Product Change Notice

1pc thermal pad instead of 2pc stacked thermal pad

AFBR-59E4APZ-HT

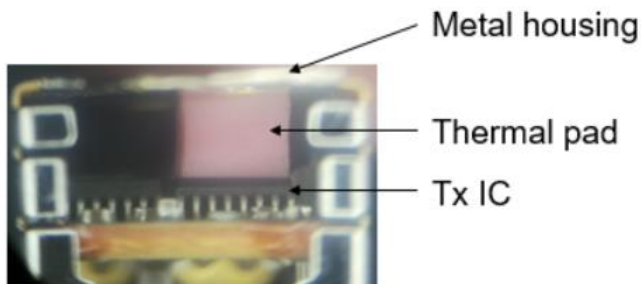
- Two pieces of thermal pads are mounted stacked between the Tx IC and housing to move heat away from Tx IC package to the housing.

- Use of a single piece thermal pad (4.5mm in height) of the same material, see picture below:

More effective thermal transfer from Tx IC to device housing and improved assembly process.
